REWORK OF COWL FLAPS

M20J S/N 24-0001 thru 24-0763 - Hinge Modification

M20J S/N 24-0001 thru 24-0854 - Doubler Modification

FIGURE 2

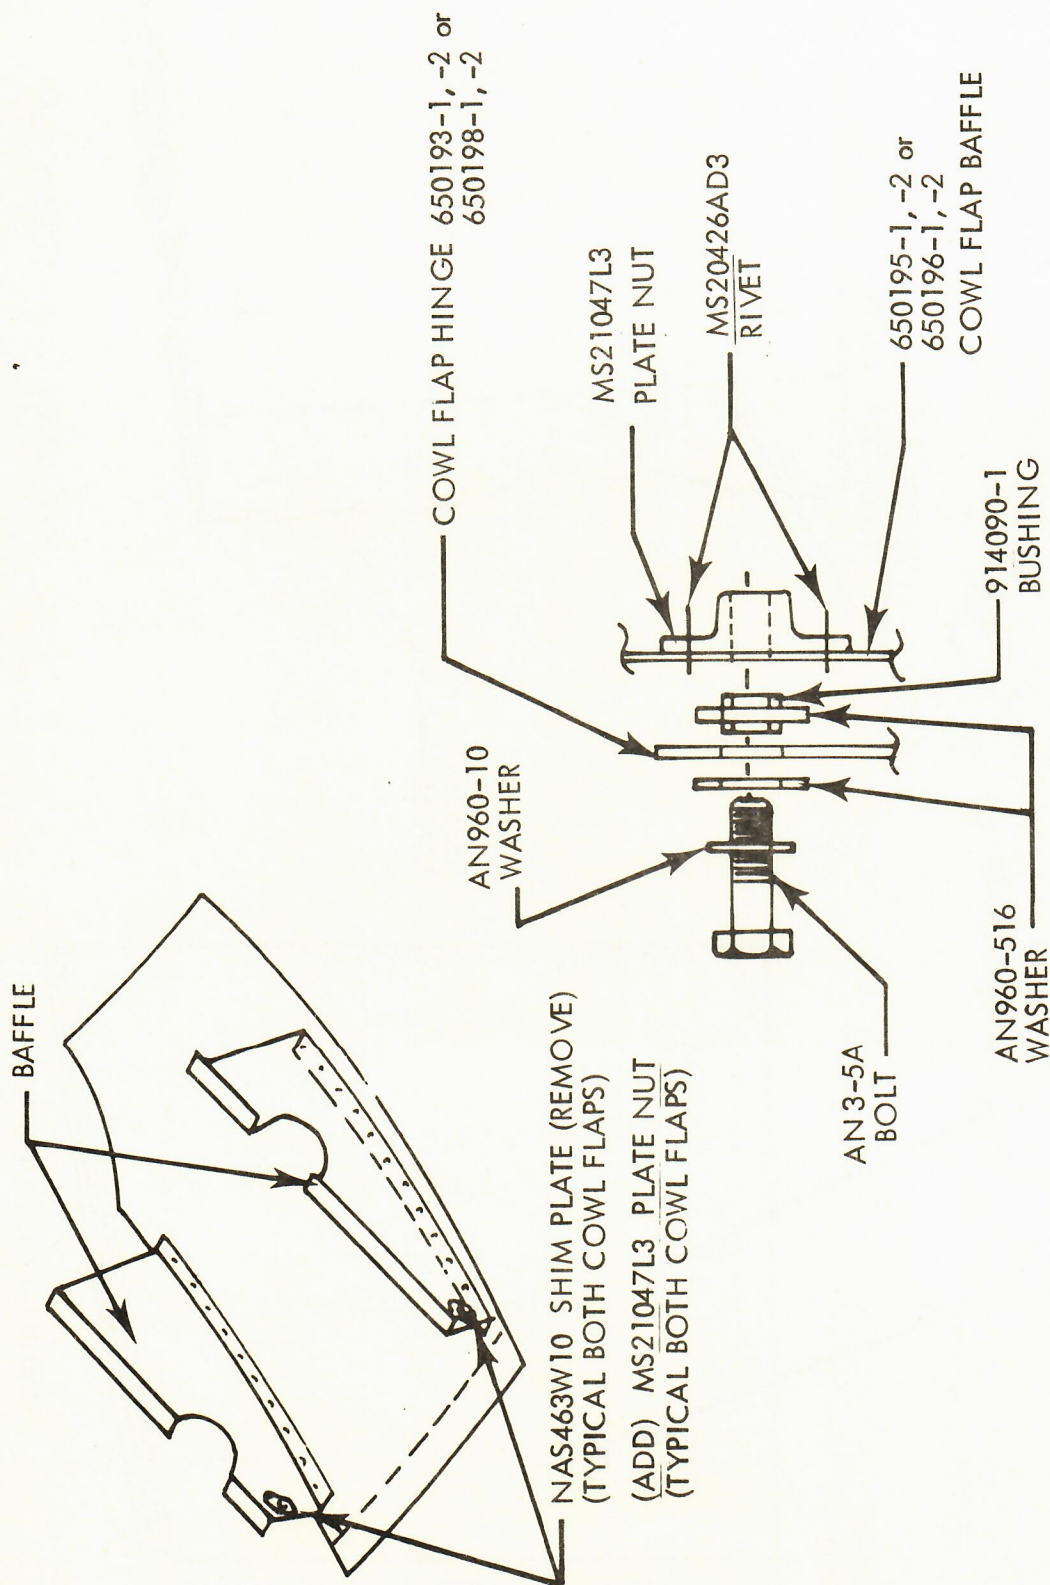
Attach doublers to appropriate baffles (See Figure 2) with clecos and mark location of holes to be drilled in baffles using the doublers as templates. Disassemble and drill holes for riveting doublers to baffles. Attach doublers to baffles using standard procedures and rivets called out.

FIGURE 1

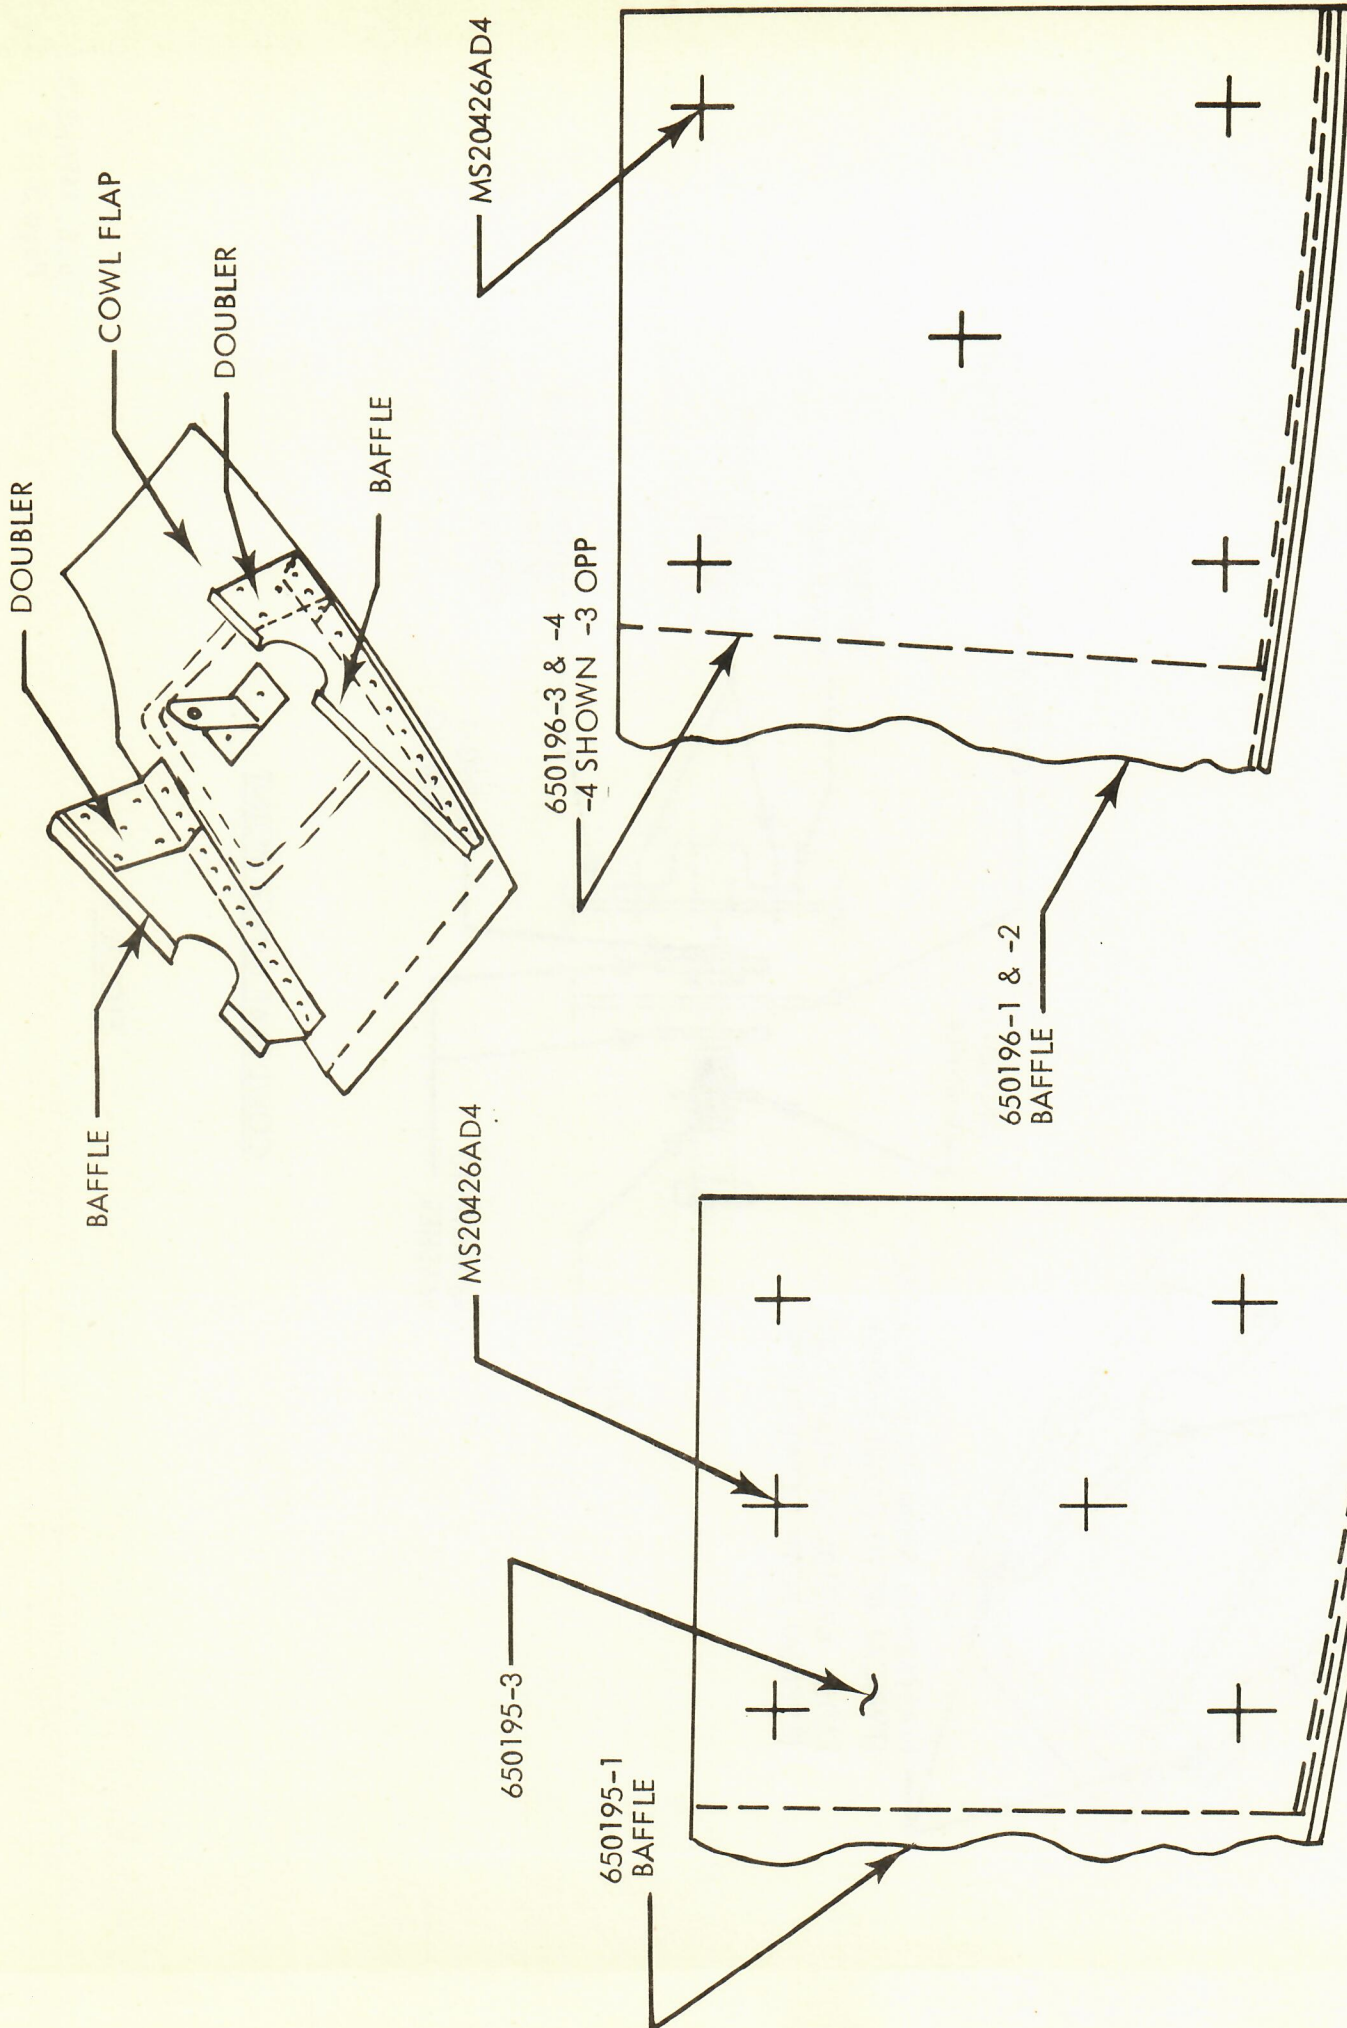
- 1) Remove lower cowling from aircraft per Service Manual, Paragraph 3-1, disconnecting all electrical and mechanical connections.
- 2) Remove both cowl flaps from lower section of engine cowl.
- 3) Drill out rivets and remove shim plate NAS463W10 (4 places) from all cowl flap baffles at hinge attach points (Ref. Figure 1).
- 4) Install plate nut MS21047L3 (4 places) using (2) MS20426AD3 rivets at each location on all cowl flap baffles. (Ref. Figure 1).
- 5) Drill or ream holes in cowl flap hinges (650193, 650198) (4 places) to a diameter of .313/.317 inches to accept bushing P/N 914090-1. This completes the hinge point modification.
- 6) Carefully drill out the aft three (3) rivets that partially attach the baffles, P/N 650195-1 and 650196-1, -2 to the cowl flaps (Ref. Figure 2). (Part number 650195-2 is a short baffle and does not require a doubler).

- 7) Reassemble the modified cowl flaps to the engine cowls (Reference Figure 1) using the bolts, nuts and bushings included in this kit. Torque the AN3-5A bolts (4 places) to 15-20 inch pounds.
- 8) Reassemble the lower engine cowl to the aircraft per Service Manual and rig the cowl flaps per Paragraph 3-24 of Service Manual.
- 9) Make entry of compliance into Aircraft Log Book and fill out the enclosed compliance card and return to: Customer Service, Mooney Aircraft Corporation, P.O. Box 72, Kerrville, TX 78028.
